REMARKS

The above amendments amend the drawing and specification to correct obvious errors and to improve clarity. No new matter is added. Attachment A shows the amendments made to the specification. Accompanying this response are (1) a request to amend the drawings and (2) a terminal disclaimer.

FIG. 1B

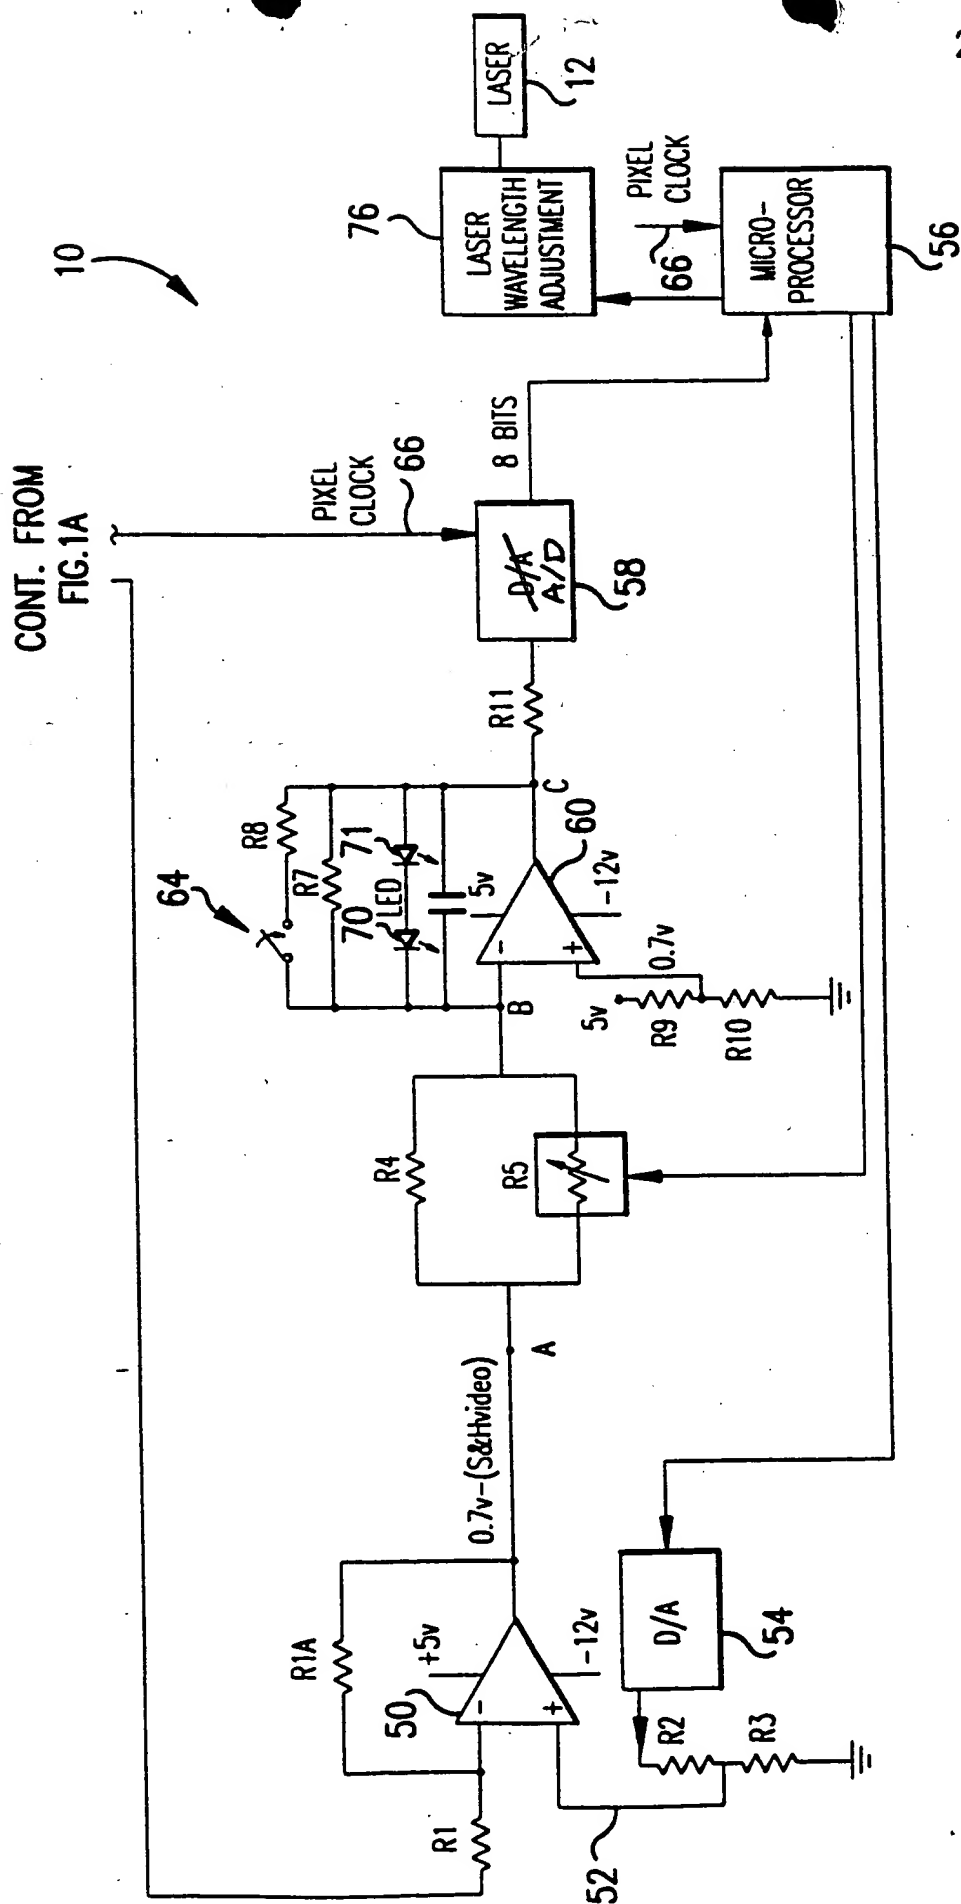
The Examiner objected to the drawings under 35 C.F.R 1.83(a) for failure to show every feature of the inventions specified in the claims. Due to a drafting error, the A/D converter 58 illustrated in FIG. 1B was marked as "D/A" instead of as "A/D" as described in the specification.

Applicant respectfully traverses the Examiner's objection. The claim describes a processing circuit controlling the gain of a first amplifier. Claim 4 states in part that "said processing circuit detects a value of a digital output of said analog-to-digital converter and controls a gain of said first amplifier." The specification describes a unity gain summing amplifier and a controlled gain amplifier as illustrated in the embodiment of figure 1B. The unity gain amplifier described in the specification is not the "first amplifier" of claim 4. The amplifier of claim 4 is the controlled amplifier as described in the specification. The corrected drawing clarifying the label of the analog-to-digital converter should also clarify the understanding of the Examiner.
